## Ichthystick II Electronic Fish Measuring Board Case CABLE ASSY IFMB-10406

WIRING DIAGRAM FOR
IcthystickII FMB Case

DWG NO. IFMB-10406

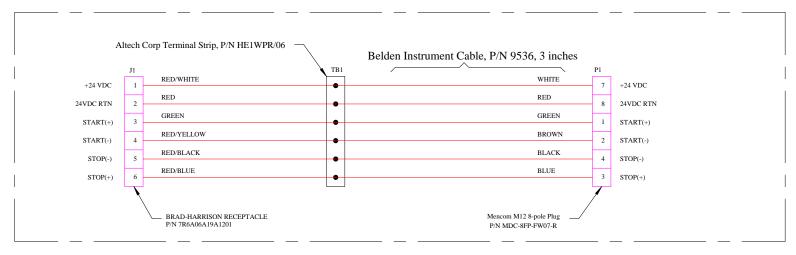
The new model EP2D (Generation 3) linear Sensor changed the output connector to an M12 (D84) male connector. Revision A of this drawing updates the mating connector to Mencom MDC-8FP-FW07-R connector which mates with the M12 (D84) receptacle on the linear sensor.
